Pre application response letter

Pre application no: 19/05220/PREAPP

Site address: Land At Broom Hill Broomhill Road Bristol BS4 4UD

Proposal: Provision of up to 300 residential units with infrastructure.

Figure 3: Age classification of the largest

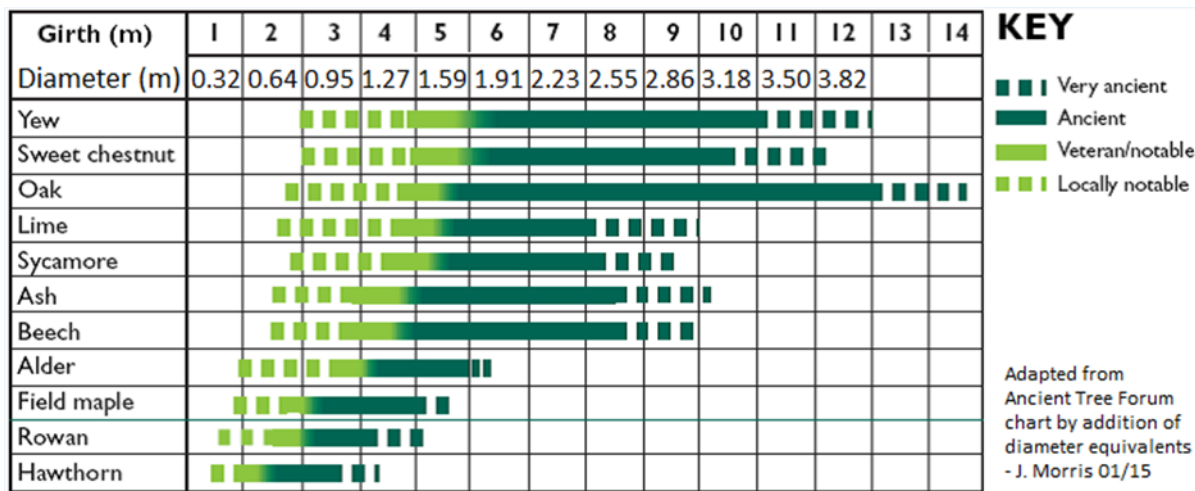
The hedgerows on site are neglected ancient hedgerows that have been in existence since before 1840. The ancient/ veteran oaks, ash and Holly within the hedgerows provide a significant historical and cultural heritage locally and must therefore be retained during any development process

- A design that retains the important ancient trees and hedgerow structure
- An arboricultural report in accordance with BS5837: 2012 (This is a validation requirement)
- A scheme of improvements and enhancements to restore the neglected hedgerow system.
- Mitigation for tree loss in accordance with Bristol’s planning obligations SPD tree
